Service Bulletin

Bulletin No.: PIT4931C

Subject: A Door May Not Open With The Outside Handle And/Or The Inside Handle

Models: 2010 - 2013 Buick LaCrosse
 2010 - 2013 Chevrolet Camaro, Equinox
 2010 - 2013 GMC Terrain

2348350

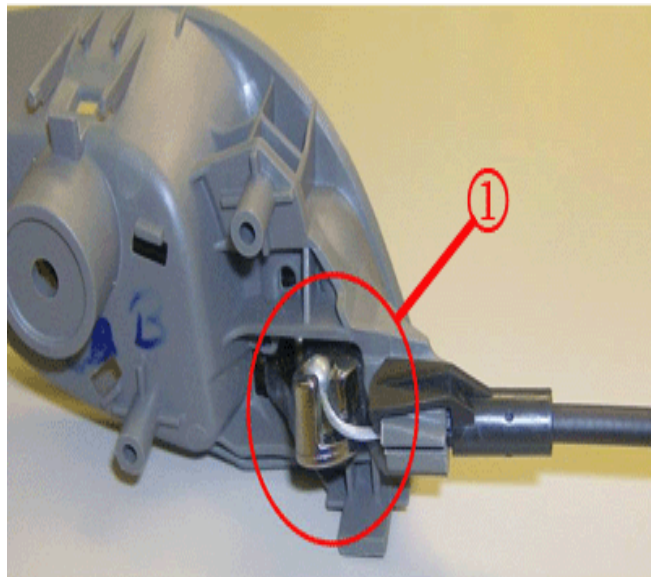
The above picture shows the inside door handle cable kinked at the inside door handle (1). If the cable is kinked, it will need to be replaced.
Incorrectly Installed

2348349

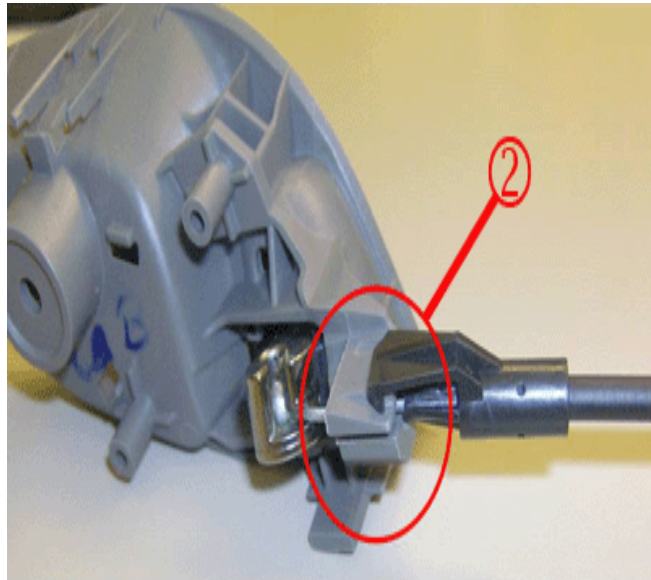
The above picture shows the inside door handle cable not fully seated to the outside door handle (2). If this concern is found, it is only necessary to push the door handle cable on to the inside door handle, to make sure it is fully seated.

2348347

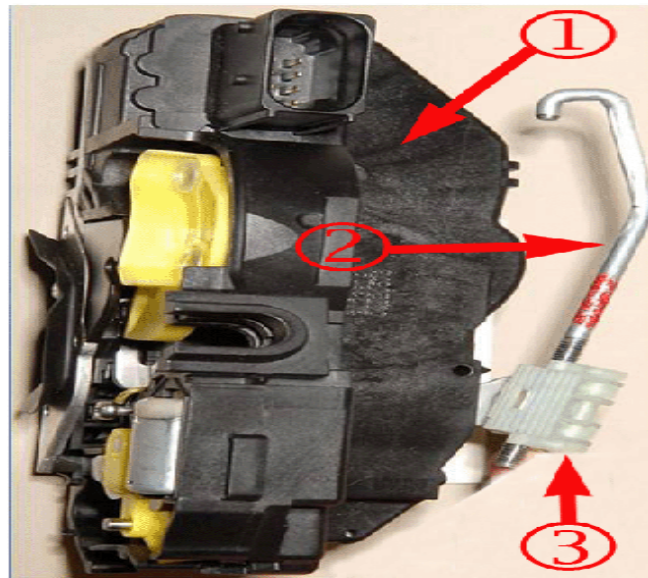
1. Door Latch Assembly.
2. Outside Handle Rod.
3. Clip (attached to outside release lever on latch)

Visually inspect the outside handle rod connection to the latch (1). Typically with a properly adjusted outside handle rod, there will be approximately an equal amount of exposed threads on both sides of the clip. To assure proper connection, disconnect the outside handle rod (2) from the white plastic clip (3) on the door latch assembly. Cycle the inside lock knob up and down at least 3 times. Make sure that the white plastic clip and lever are in the full up position while reinserting the rod into the clip.
